Mona Vale Road East upgrade – Manor Road, Ingleside to Foley Street, Mona Vale

Submissions Report
December 2015

Mona Vale Road East Upgrade

Submissions report
December 2015

Design changes to proposed Mona Vale Road East Upgrade Fig. 4-1

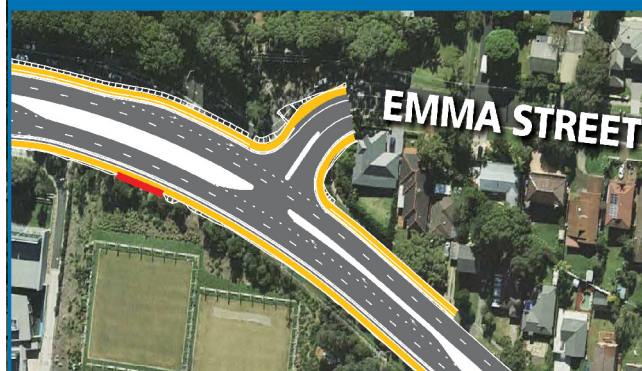
- Shortening of the Samuel Street concrete median to improve property access near the Mona Vale Road intersection
- A revised location for the truck arrester bed, about 300 metres further west on Mona Vale Road (refer to **Figure 4-1**). The design change moves the proposed truck arrester bed away from residential properties on Walana Crescent / Wallaby Circuit and the Mona Vale General Cemetery

The relocation of the utilities away from Mona Vale Road and into a combined corridor within Lane Cove Road provides an opportunity to develop an additional multi-use shared path away from the Mona Vale Road corridor. This would be in the form of a concrete path along the proposed utility corridor within the existing road reserve of Lane Cove Road, either to the north or south of the existing road reserve (refer to **Figure 4-1** for location of proposed utility corridor).

Intersection changes Fig. 4-2

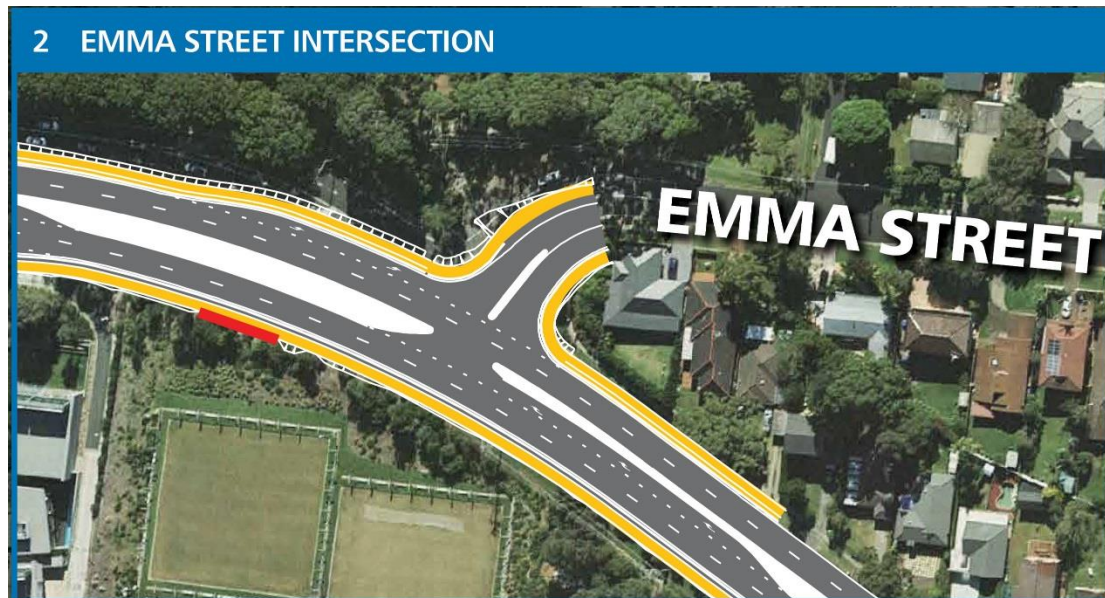
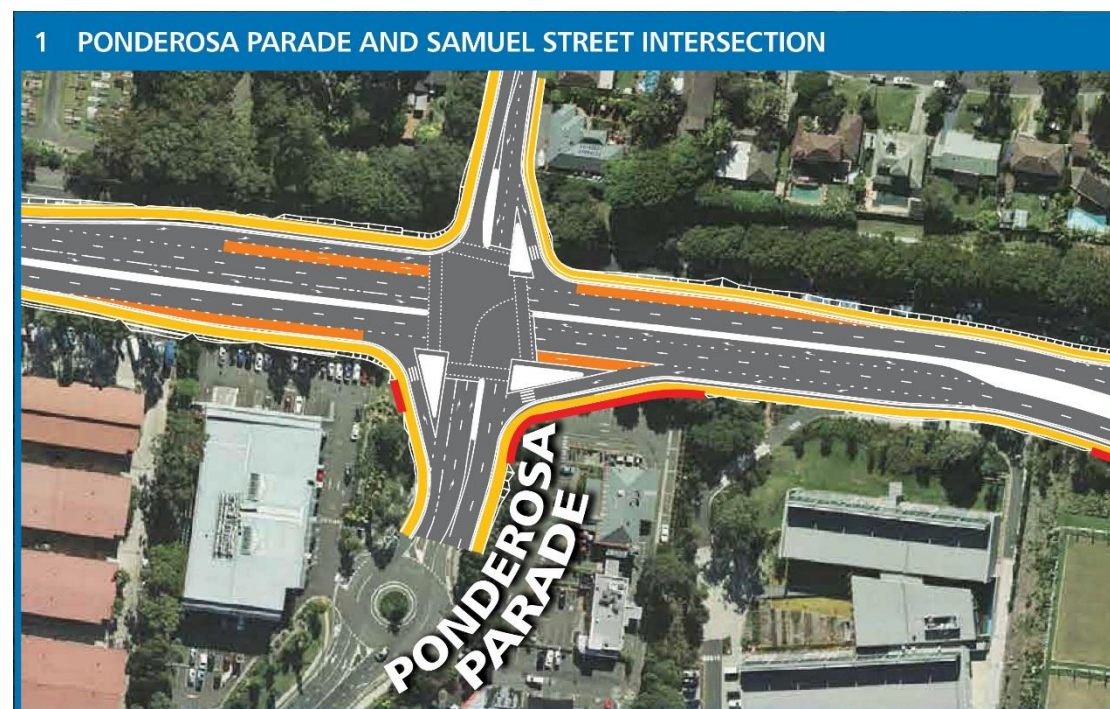
- 2) With the change in access arrangements for Emma Street there is concern that there will be increased traffic on the streets surrounding the Mona Vale Public School (Waratah Street, Wangara Street, Oliver Way and Bungan Street) where currently the traffic around the school is predominantly associated with local residents and with school drop offs and pick-ups. There is concern for school children safety. In addition the school bus currently travels Waratah Street to Maxwell Street and on to Emma Street in order to access onto Mona Vale Road. This route will need to be altered leading to additional travel time for the bus and exacerbating the anticipated congestion on the alternative routes.

- 4) Some respondents are concerned about the potential increase in traffic on Whitney Street as a result of the proposed change to turning movements at Emma Street (left in and left out only). It is considered likely that traffic will use Whitney Street as a shortcut between Parkland Road and Samuel Street causing congestion, safety concerns for pedestrians, increased road traffic noise and difficulties accessing properties. Some respondents requested that Whitney Street should be closed (by creating a cul-de-sac or similar) to through traffic to prevent this from occurring.

The revised layout of the Mona Vale Road and Emma Street intersection is shown in **Figure 4-2** and extracted below.

The revised intersection layout includes a channelised right turn layout with a sheltered right turn bay in the median of Mona Vale Road for right turning vehicles turning into Emma Street. The revised intersection layout retains all existing traffic movements and ensures that access is retained for local residents seeking to continue utilising the intersection.

The revised lane configuration of the Mona Vale Road / Ponderosa Parade / Samuel Street intersection is shown in **Figure 4-2** and extracted below.

Figure 4-3 Truck arrester bed profile

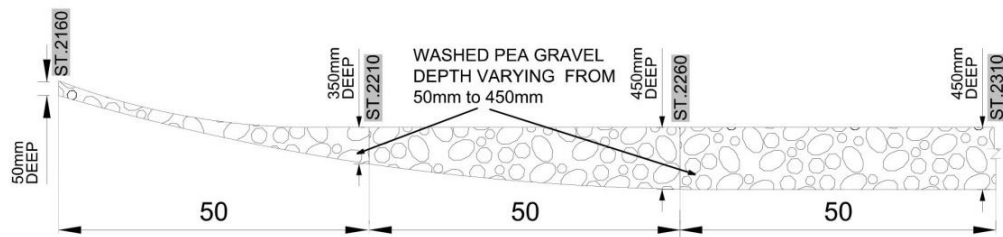
- Changing the Emma Street intersection to left turn in and left turn out only
- Location of truck arrester bed, about 150 metres long, for eastbound vehicles adjacent to Walana Crescent

The original proposal presented in the REF, includes provision of a truck arrester bed next to the eastbound lane approaching Walana Crescent, near the bottom of the steep descent. Alternative locations were investigated by Roads and Maritime in response to community feedback. The revised location for the truck arrester bed is about 300 metres further west up Mona Vale Road next to the eastbound lane (refer to **Figure 4-1**). This moves the proposed truck arrester bed away from residential properties on Walana Crescent / Wallaby Circuit and the Mona Vale General Cemetery.

The purpose of the arrester bed is to provide a safe 'escape route' for heavy vehicles with braking problems. The heavy vehicle is safely decelerated and stopped by the drag caused by the vehicle as it sinks into the bed material. The proposed arrester bed would be five metres wide and about 150 metres long. The bed material would be washed pea gravel to a depth varying between 50 millimetres and 450 millimetres. A 4.5 metre wide shoulder would be constructed adjacent to the arrester bed to facilitate maintenance. **Figure 4-1** shows the truck arrester bed as part of the broader proposal, while **Figure 4-3** shows the proposed arrester bed profile.

Figure 2-4 Mona Vale Road / Ponderosa Parade / Samuel Street concept intersection layout

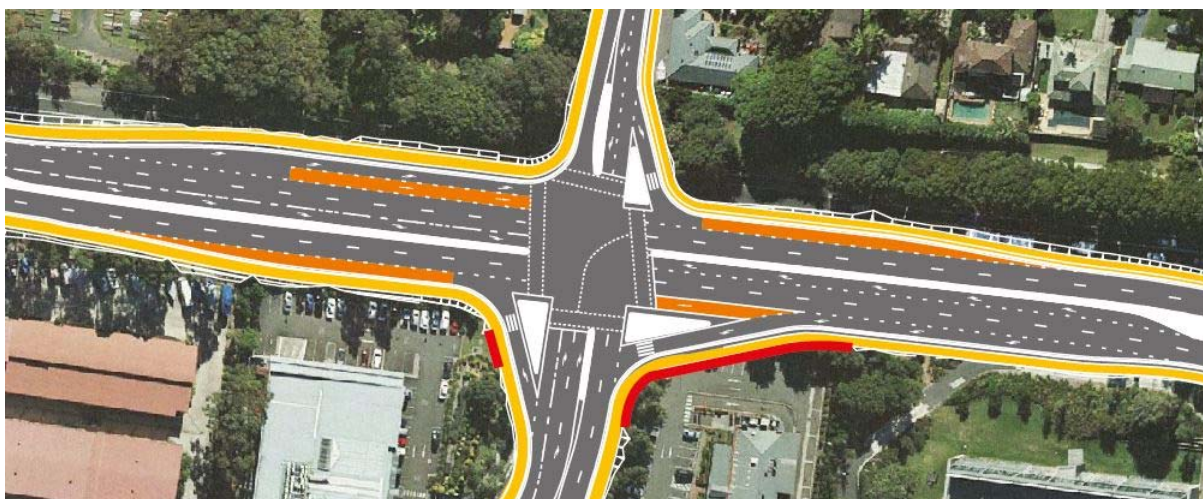
- 1) Concern regarding restricted property access and manoeuvrability with addition of a concrete median barrier on Samuel Street.
- 2) Concern regarding the introduction of a left turn slip lane into Samuel Street due to the need to remove some mature trees at the corner of Mona Vale Road and Samuel Street and partially acquire property on Samuel Street to accommodate the slip lane. In addition there is concern that traffic turning left into Samuel Street using a left turn slip lane may not reduce speed to enter Samuel Street which has a posted speed of 50 km/h.
- 3) An increase in traffic numbers is anticipated on Samuel Street with the proposed changes to Emma Street (left in and left out only). Respondents raised concerns about congestion, increased queuing times, noise impacts, and safety on Samuel Street.

The layout of the Mona Vale Road / Ponderosa Parade / Samuel Street intersection has also been identified for adjustments as a result of a review of impacts on property and access and the need for property acquisition. The footprint of the northern approach of the intersection has been reviewed. The revised layout of the intersection includes the removal of the left slip lane from Mona Vale Road (west) onto Samuel Street. The proposed lane configuration of the Mona Vale Road / Ponderosa Parade / Samuel Street intersection is shown in **Figure 2-4**.

The layout of this intersection includes dedicated left turn lanes on all approaches, with left slip lanes provided on all but the western approach of Mona Vale Road. Short bus only lanes are provided in order to accommodate the higher volume of buses forecast to be provided by Transport for NSW. It is estimated that this will include a bus service approximately every 5 minutes in the peak hour (peak direction) by 2021, with further enhancement to services by 2031. In the interim period (until bus numbers grow) it would be possible for general traffic to utilise this lane space without impacting the performance of the intersection.
